**City of Phoenix**

**Staff Report Z-79-21-7**

Light Industrial

Southeast corner of 27th Avenue and Buckeye Road

Conceptual Colored Site Plan, Source: Butler Design Group

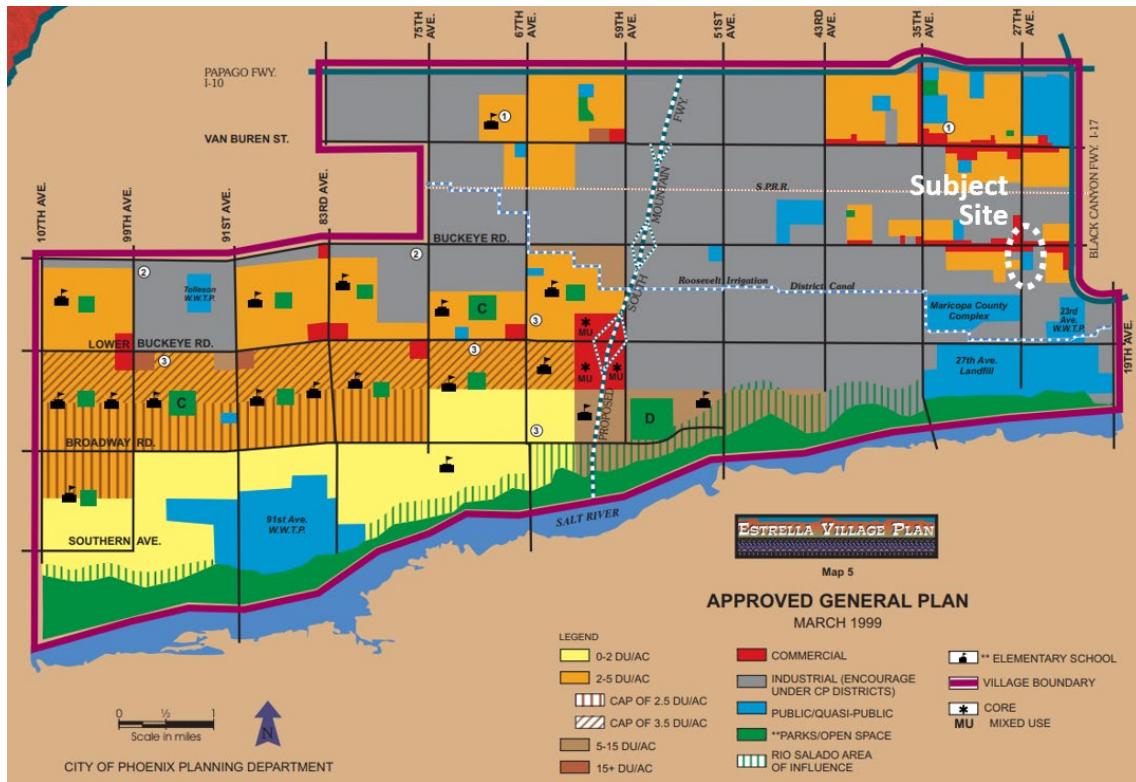
Staff is recommending general conformance to this site plan, per Stipulation No. 1, to ensure that the site develops as proposed. The proposed buildings are oriented toward the street frontages, and truck parking and loading areas are located in the rear of the buildings, screened from the public street. Lastly, the large setback from Buckeye Road is appropriate and consistent with the Estrella Village Character Plan.

Staff recommends 400 square feet of employee resting area that incorporates seating and shade to allow site employees a place outdoors during their workday. This area would be shaded a minimum of 75 percent using minimum two-inch caliper large canopy drought-tolerant shade trees and/or architectural shade. This is addressed in Stipulation No. 6.

1. The development shall be in general conformance with the site plan and building elevations date stamped December 21, 2021, as modified by the following stipulations, and as approved by the Planning and Development Department.

6. One outdoor employee resting area of no less than 400 square feet or two 200-square foot areas shall be provided on site. Each required pedestrian area shall include a minimum of two pedestrian seating benches, constructed of quality and durable materials, and shaded to a minimum of 75 percent using minimum 2-inch caliper large canopy drought-tolerant shade trees and/or architectural shade, as approved by the Planning and Development Department.
